PLANNING COMMITTEE Regulatory Committee Agenda

APPLICATION REPORT - HH/345153/20

Proposal: Two storey rear extension
Location: 2 Lower Tunstead, Tunstead Lane, Greenfield, OL3 7NT
Case Officer: Sophie Leech

Application Nos. HH/345153/20 & LB/345154/20

Proposed plans

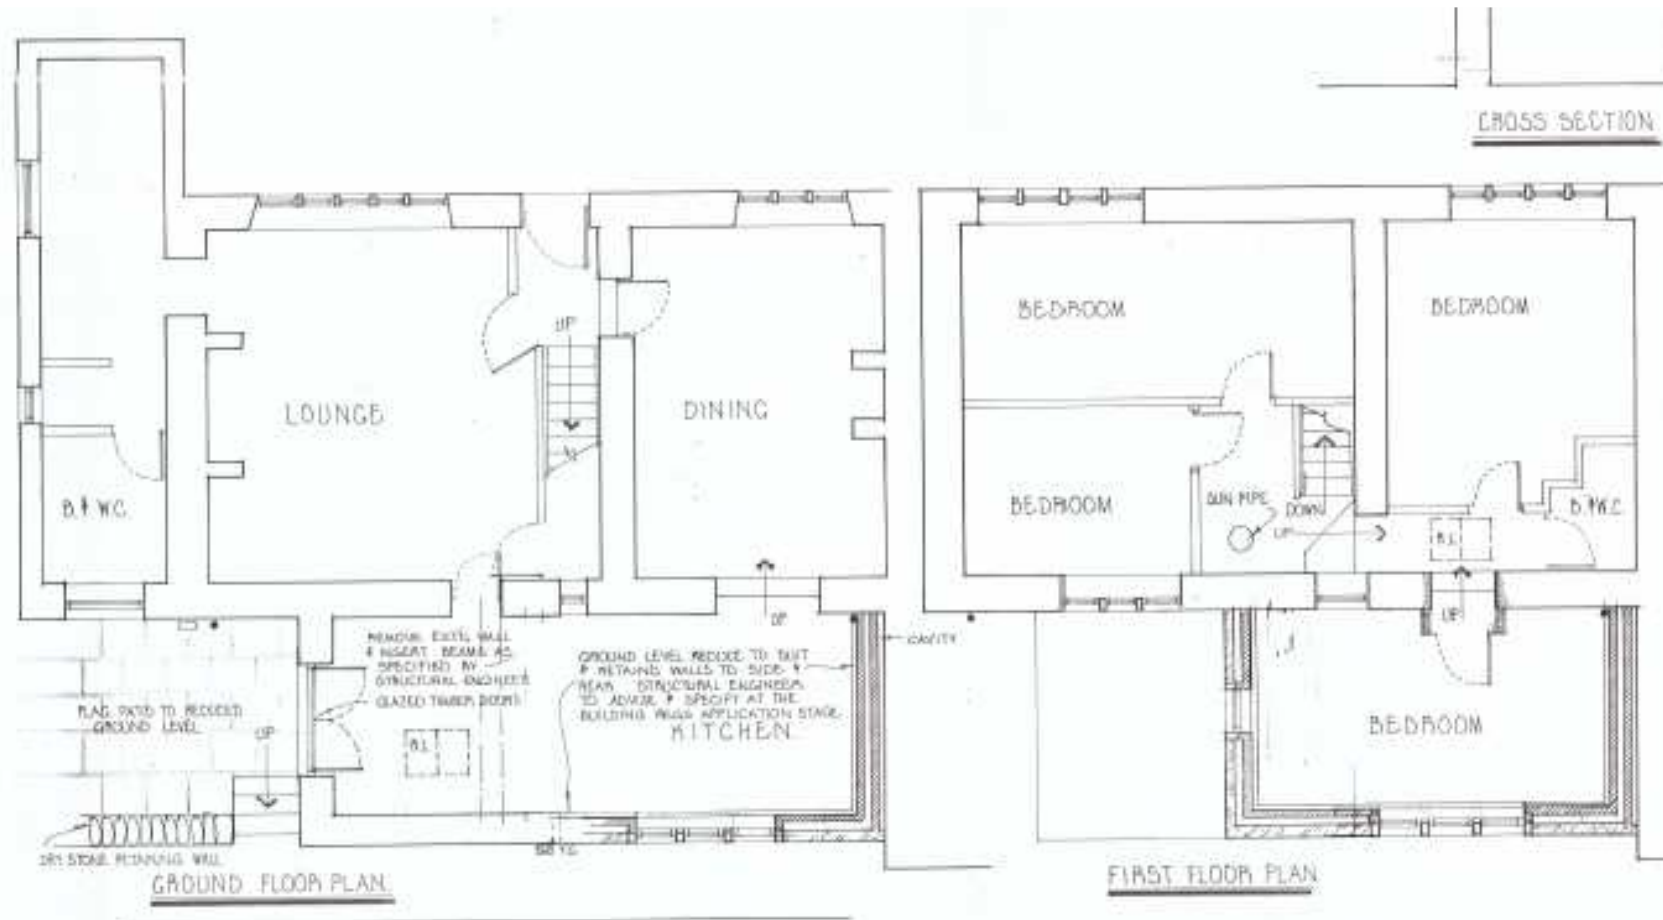
The proposed extension will incorporate part of the existing single storey. Although covering two storeys it would have a squat appearance with the eaves created at a lower level to the main building below a mono-pitch roof which continues down from the rear wall. This relationship will remain notwithstanding the revision to the plans which removes the slightly askew angle between the extension and main roof pitches.

Four rear facing windows were originally proposed, which appeared of varying scales and alignment and dominated the rear wall, along with a first floor corner window.

The rear windows have now been altered to provide a more ordered matching design. The corner window has been removed and replaced with a small window opening on the side elevation. Whilst the design of the windows is a slight improvement to the earlier scheme, the overall changes do not overcome the fundamental concerns raised with regards to the scale of two storey extension in relation to this listed building.

Existing and proposed elevations

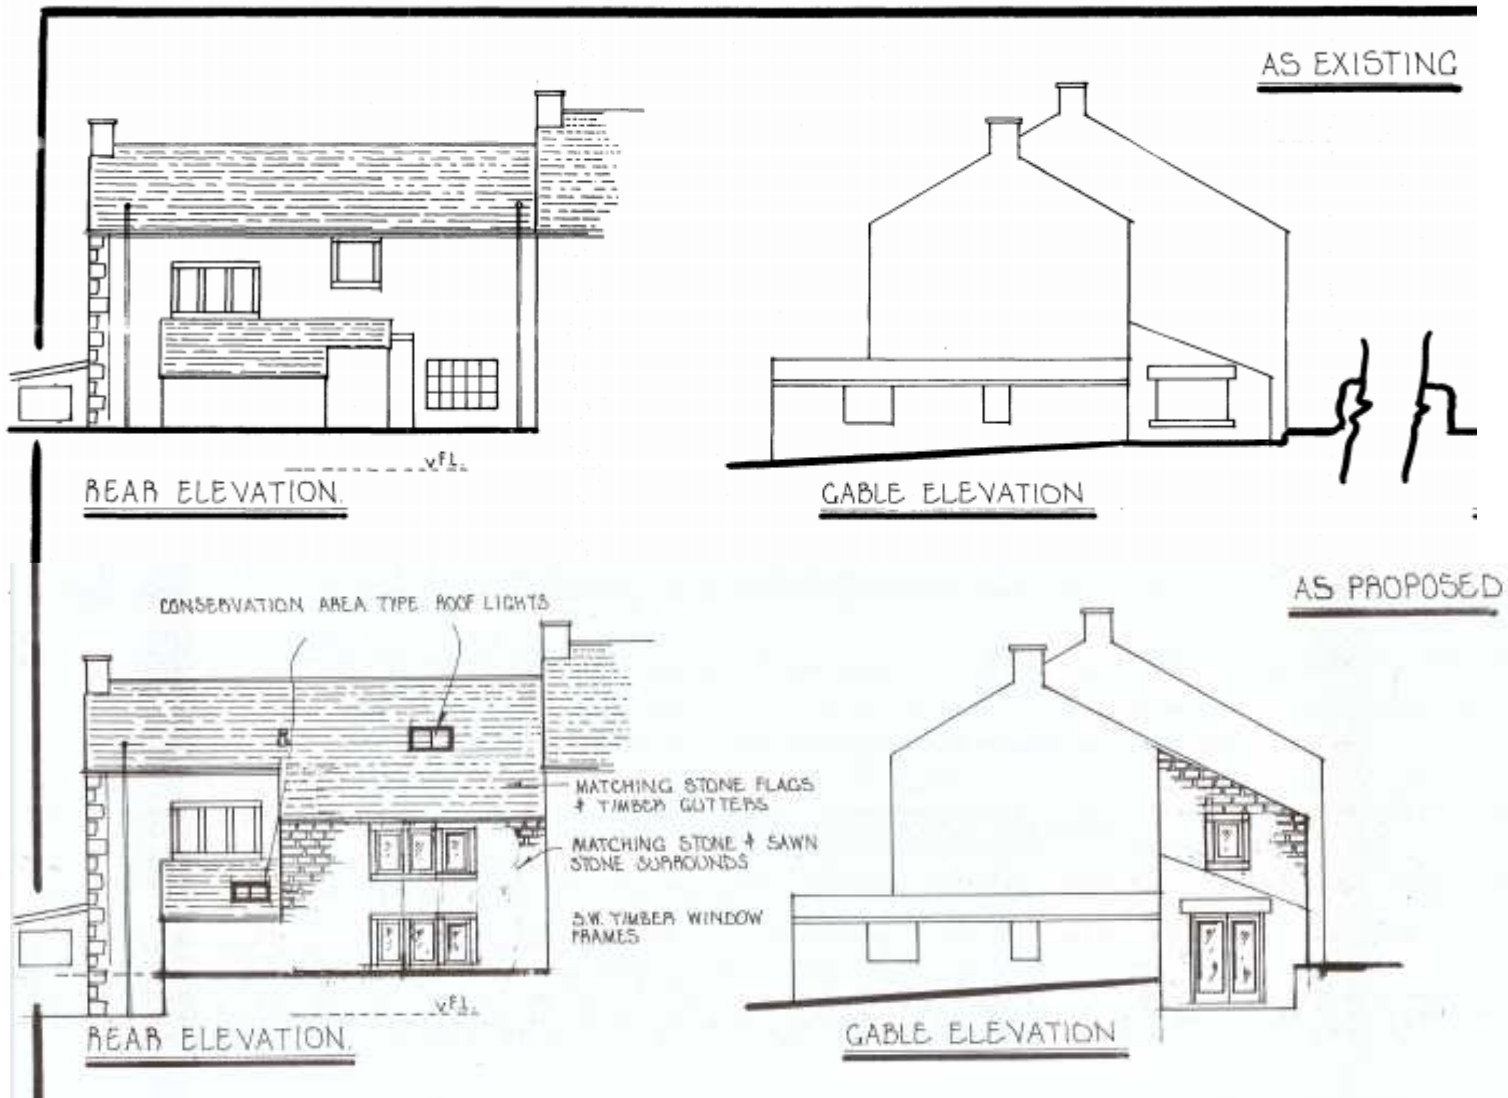
The existing rear elevation has few windows and the stonework would suggest none have been blocked up. It is clear that this was designed in such a way for a particular reason. The applicant suggests that there could have been limited windows as the rear of the site is north facing, therefore preferring to have the building sealed from the weather. In addition, the statement notes that the existing bay window is not an original feature.

1. The proposed extension represents a visually incongruous addition to the historic building by reason of its appearance, scale and resultant fenestration. As such it would cause 'less than substantial harm' to the significance of a heritage asset, as assessed by Paragraph 196 within the NPPF. No public benefits have been demonstrated to outweigh the identified harm, and therefore, the proposal would be contrary to the requirement of Section 66(1) of the Planning (Listed Buildings and Conservation Areas) Act 1990, Policies 9, 20, and 24 of the Oldham Local Development Framework and Part 16 (Conserving and enhancing the historic environment) of the National Planning Policy Framework.
